# Feedback

Corrected parts-placement guide for the Micro-TO Message Keyer, shown at slightly reduced size. This view is from the component side; the shaded area represents an X-ray view of the copper pattern. J = wire jumper. K indicates the cathode of a diode.

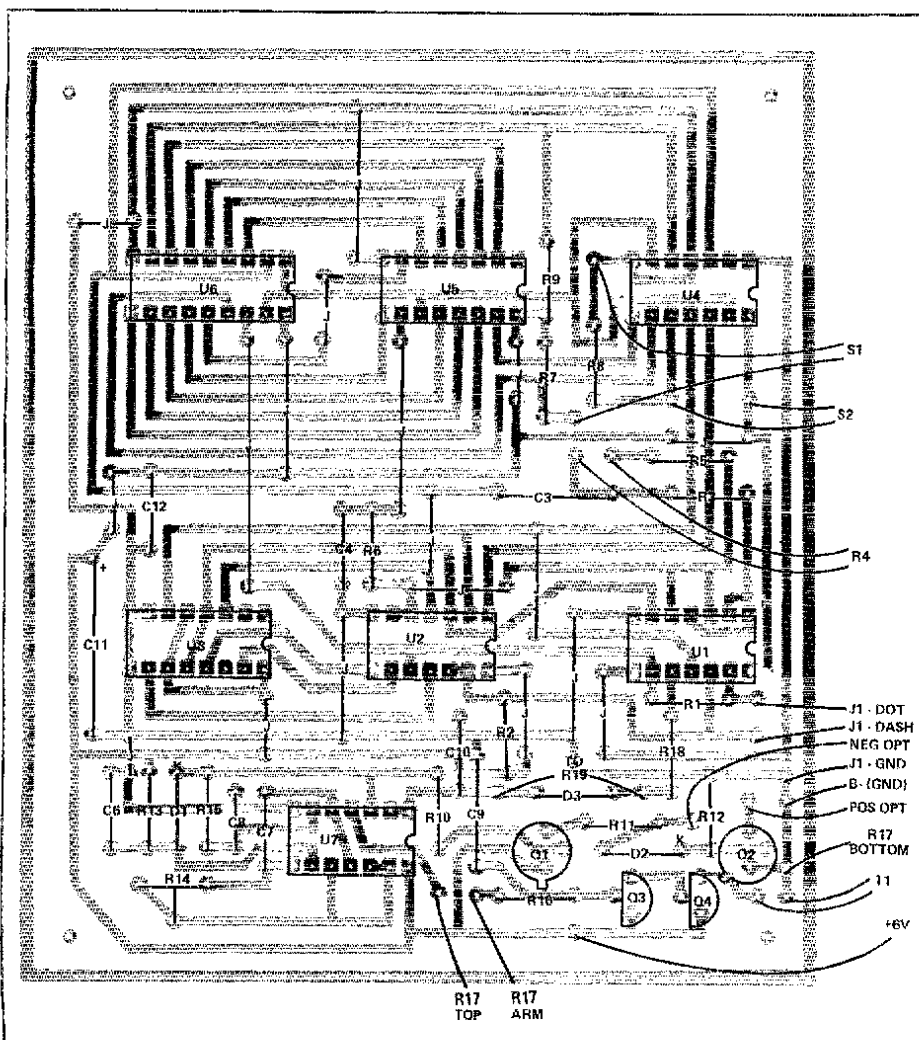
□ Misinformation appears in the parts-placement guide for "The Micro-TO Message Keyer" (Opal, February 1978 *QST*). Although the etching pattern on page 14 is correct, the orange overprint is not. Reproduced here is a corrected parts-placement guide.
